**Substantive response of the Local Highway
Authority to a planning consultation received
under The Development Management Order.**

Planning Application Number: P/20/2380/2

Application Address: Barkby Road Queniborough Leicestershire

Further observations. Outline application for up to 150 dwellings, together with new open space, landscaping and drainage infrastructure, with all matters reserved except for access.

Figure 15: proposed mitigation scheme at the Queniborough crossroads (ADC1659-DR-002-P2)

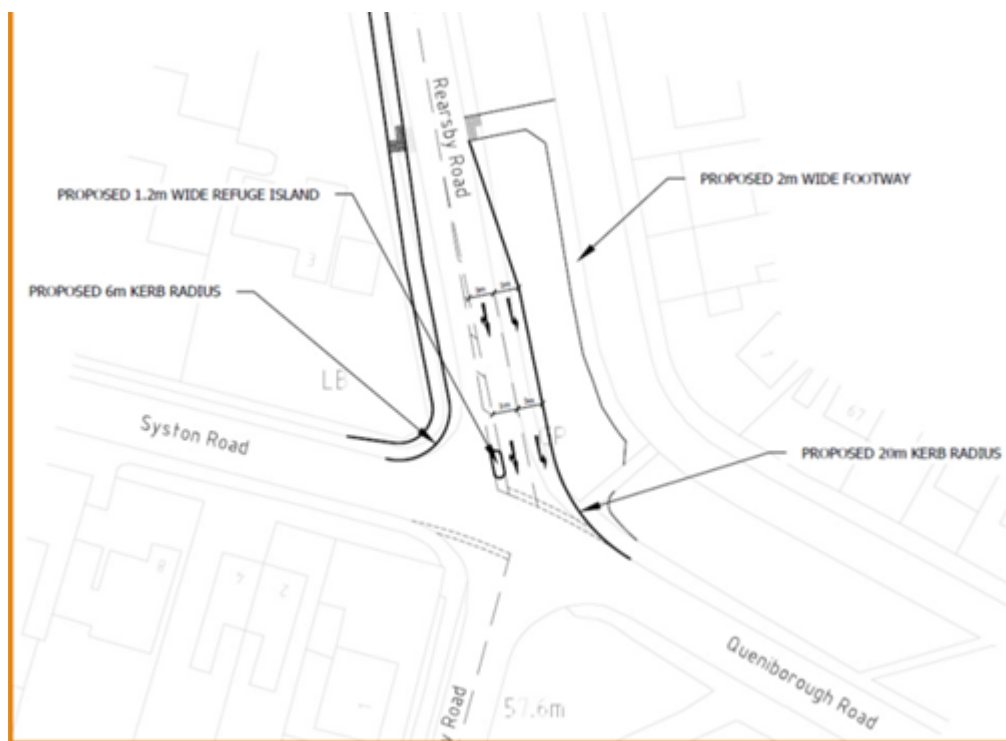
Drawing ADC1659-DR-002-P2 has been produced, which shows a 1.2m wide traffic island on the southbound approach to provide separation between entry and exit traffic. The island has been designed in accordance with an LCC standard detail for a non-pedestrian island.

The eastern footway would be rerouted behind the existing row of trees to provide pedestrian connectivity between Rearsby Road and Queniborough Road. A new section of footway would also be provided on the western side of Rearsby Road to facilitate pedestrian connectivity to the existing zebra crossing, to the north of the junction. The TA sets out that the road widening has been purposefully minimised to avoid damaging impact on the root protection areas of the trees.

Whilst the junction would operate beyond its practical capacity on two of the movements, the LHA agrees with the findings of the TA that the mitigation scheme produces a greater than nil-detriment mitigation when compared with the existing junction layout. In the worst case morning peak hour, the delay on Rearsby Road reduces from 283 seconds per vehicle without the development, to 257 seconds with the development and the mitigation scheme. The queue on Rearsby Road reduces from 43 vehicles to 37 vehicles.

3. No part of the development shall be occupied until such time as the offsite works shown on drawing number ADC1659-DR-002-P2 and ADC1659-DR-001 have been implemented in full.
